# Inspection of 3 pole connectors following 2 failures of July 2012 delivery

Failures of the first production made by Mrs Wang for RE1, 2 & 3.

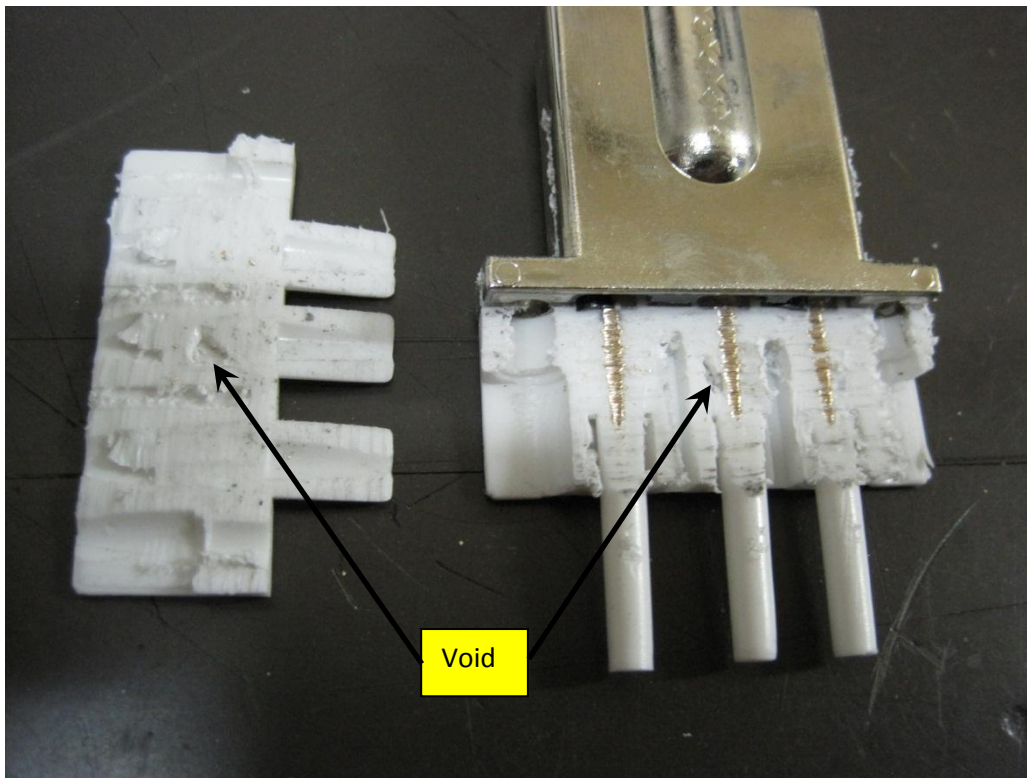
Another void next to centre pin

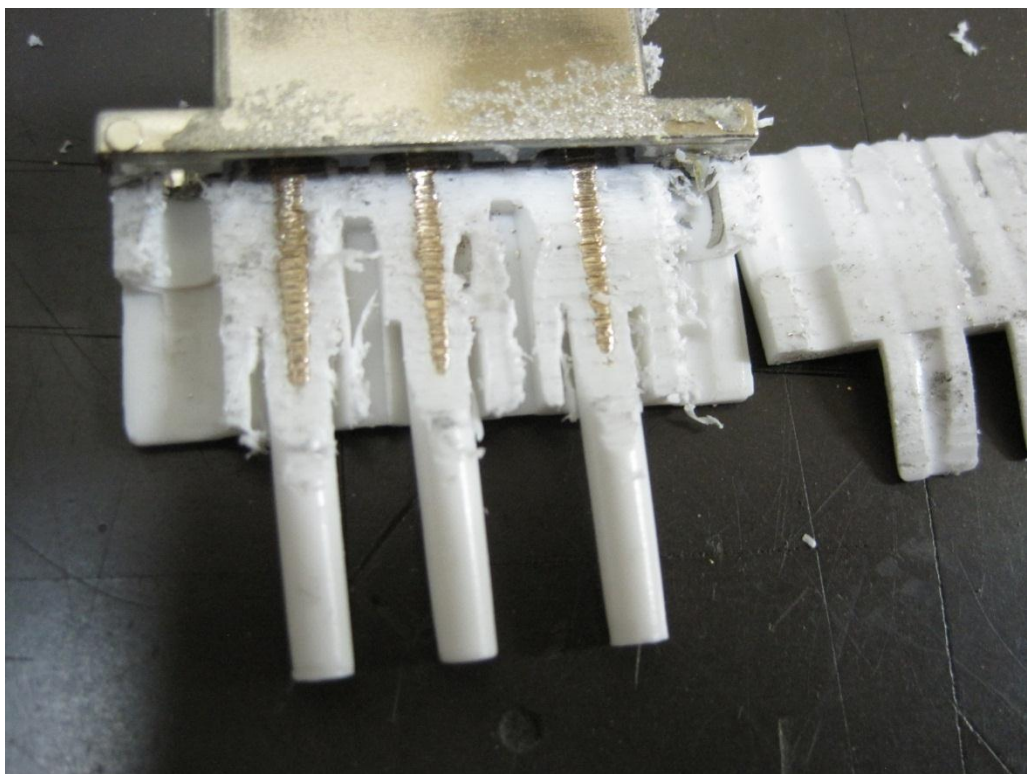
And another

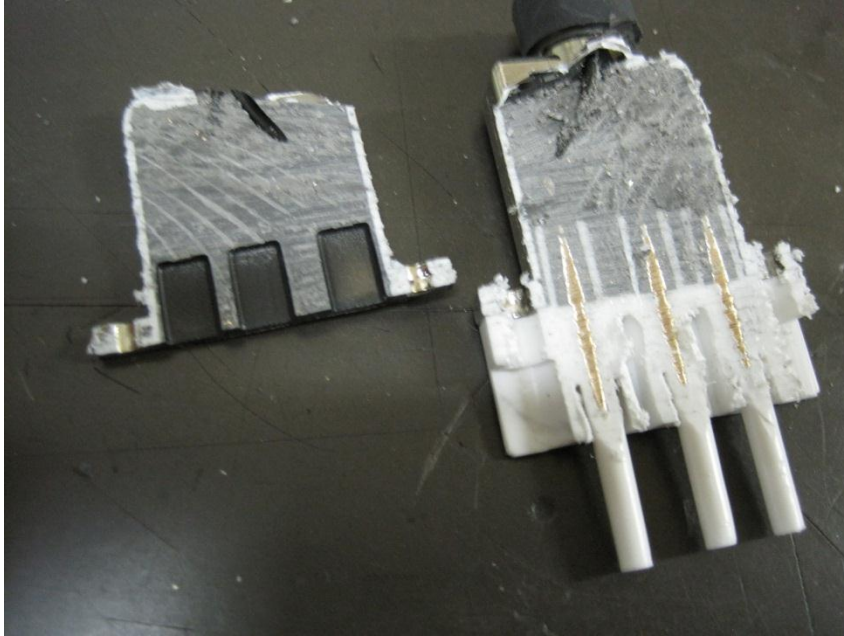
Examples of in correct moulding of the intentional gaps between individual pins.

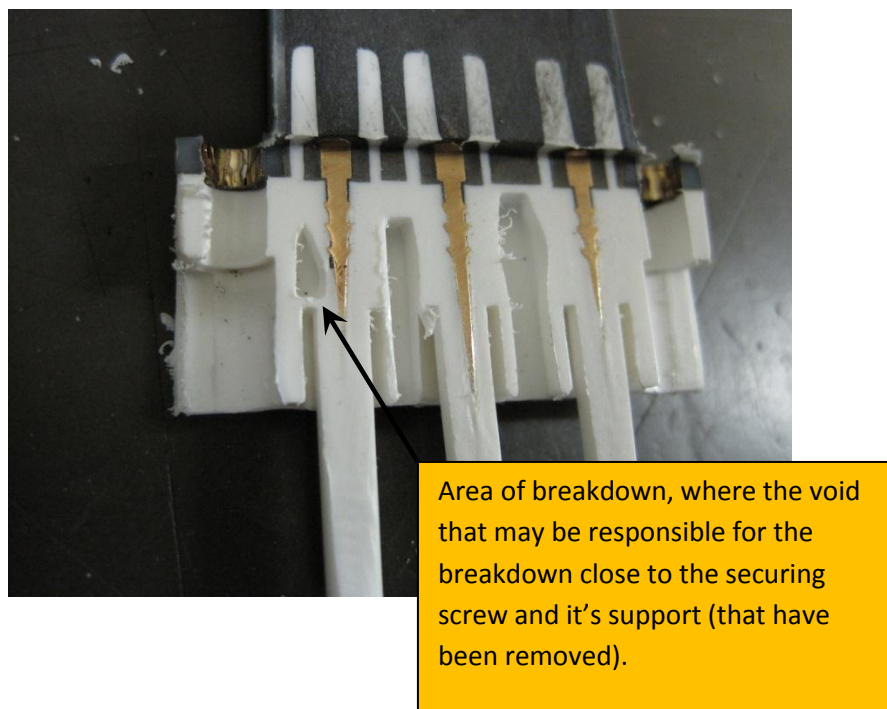
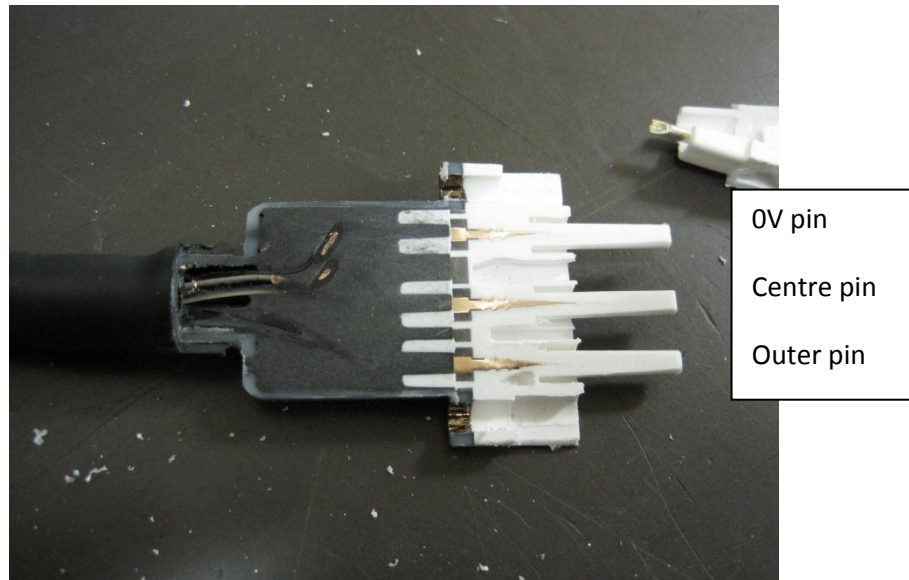
The first failure, 2 of 12, of the delivery this July 2012.

The connector failed before reaching 15kV, at approx. 13kV, on the outer of the 2 "live" pins. Loud cracking and light was visible through the white area of the connector close to the securing screw.

The connector was milled through, 0.5mm for each pass, by Jean Francois looking for the origin of the breakdown.

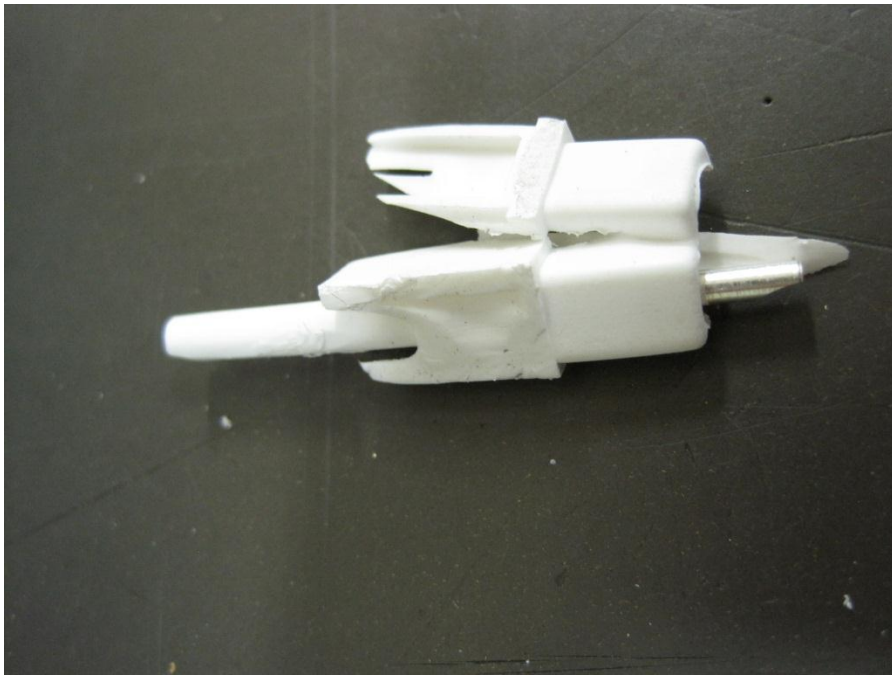
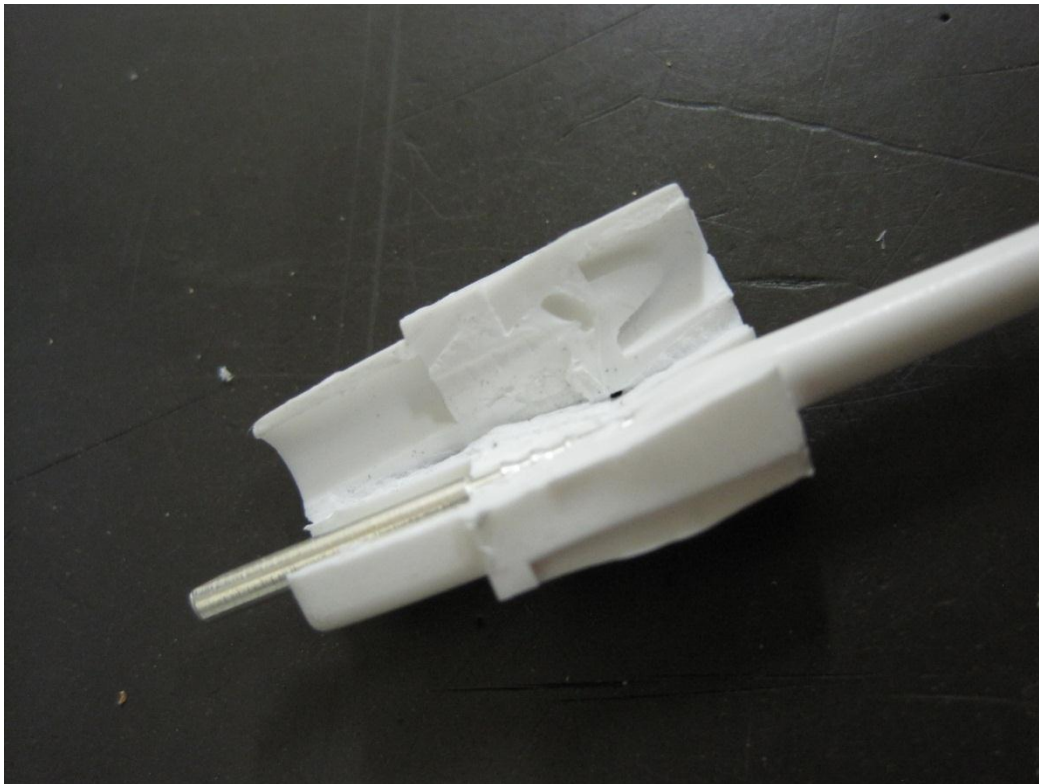
Examples of voids in similar locations

Another example. If these are outer pins or centre is not clear.

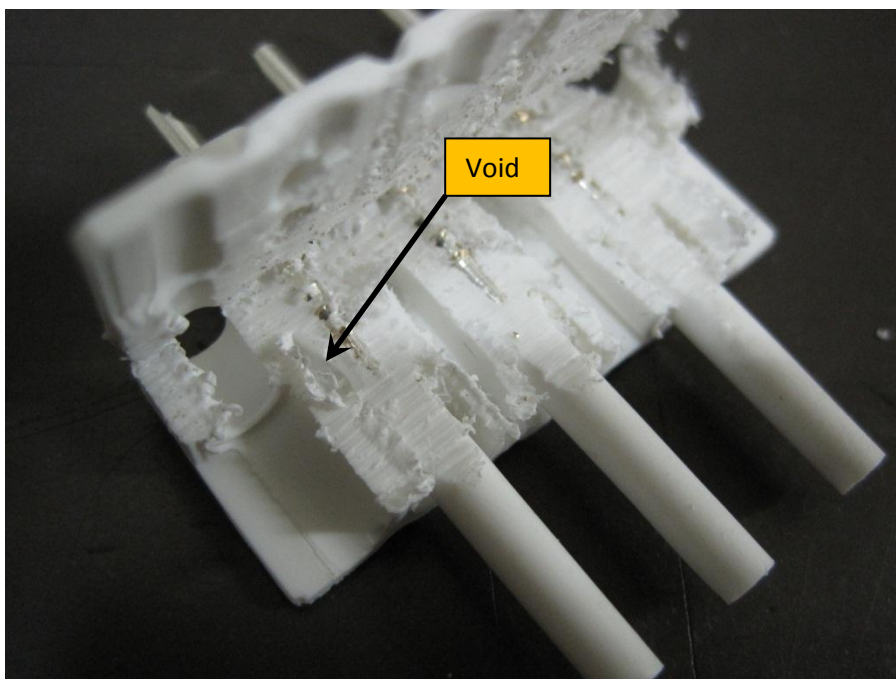
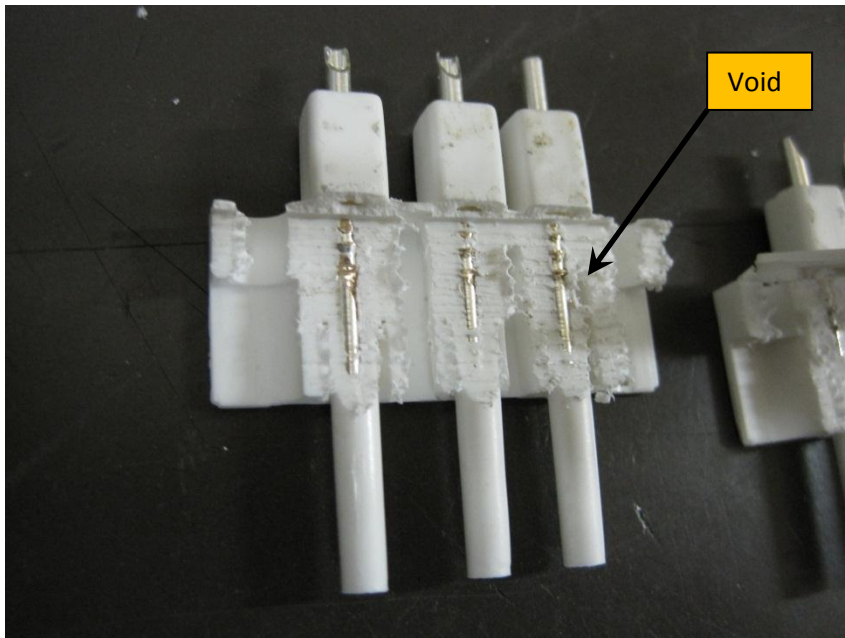
Two of the 5 opened by hand show voids between the outer pin and the securing screw emplacement. They are shown below.

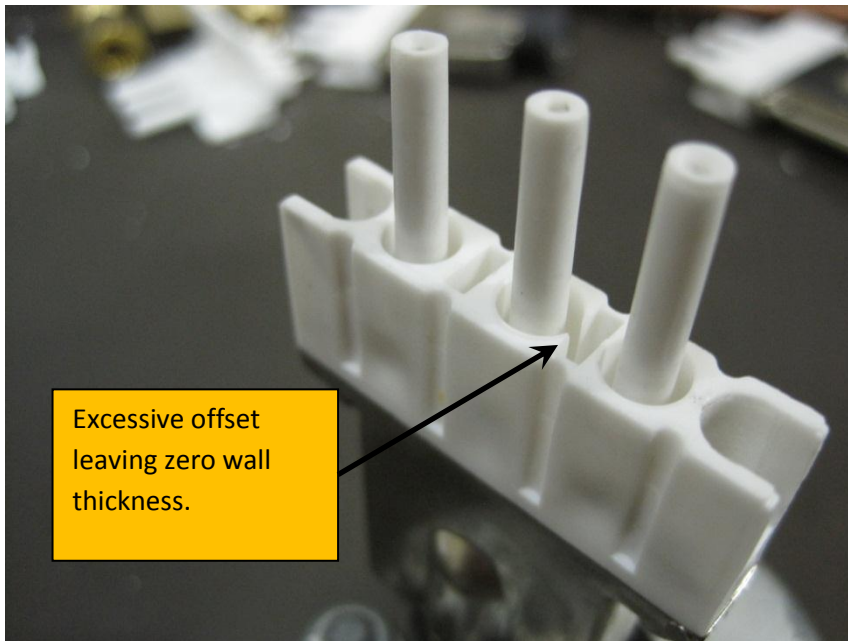
Other faults;

This bad mould geometry is inherent to all connectors of whatever age.

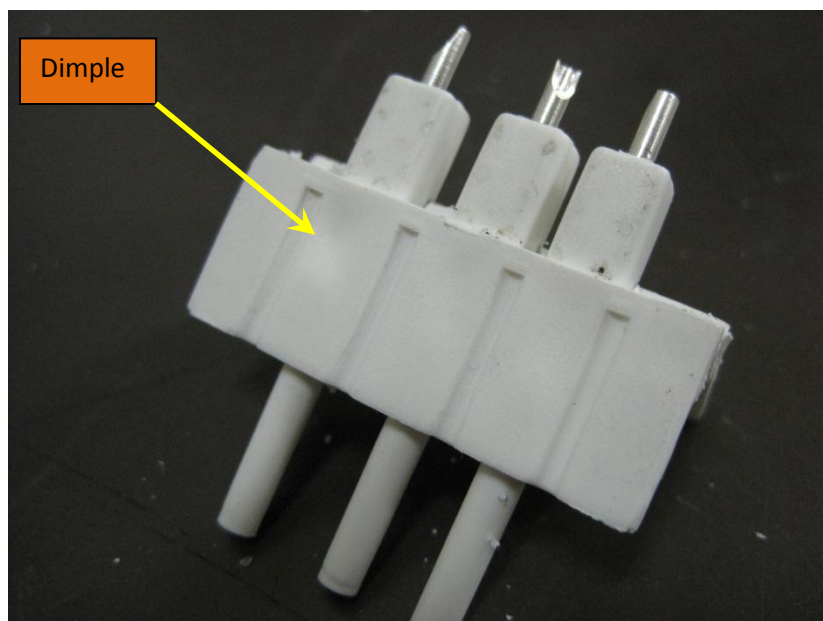
Dimples (sinkage) are present in many cases. They seem to coincide with the internal voids, as logically a lack of dimple implies that the material has not shrunk into the low density area but has remained in its initial condition so producing the voids.

Dimple is on the left and the void is on the RHS

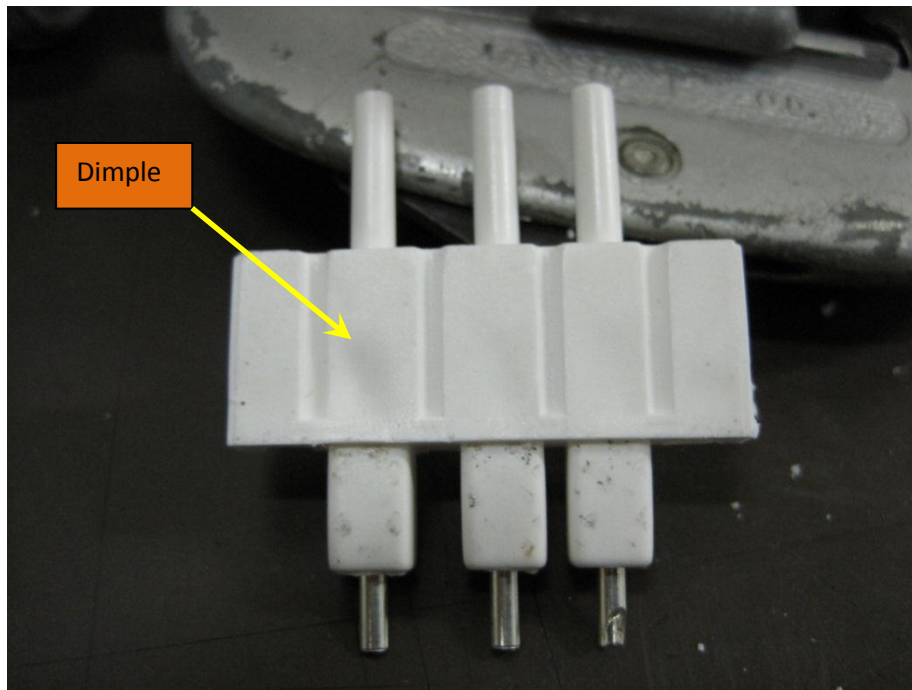
The second of 5 samples. The dimple is on the left and the void is on the RHS
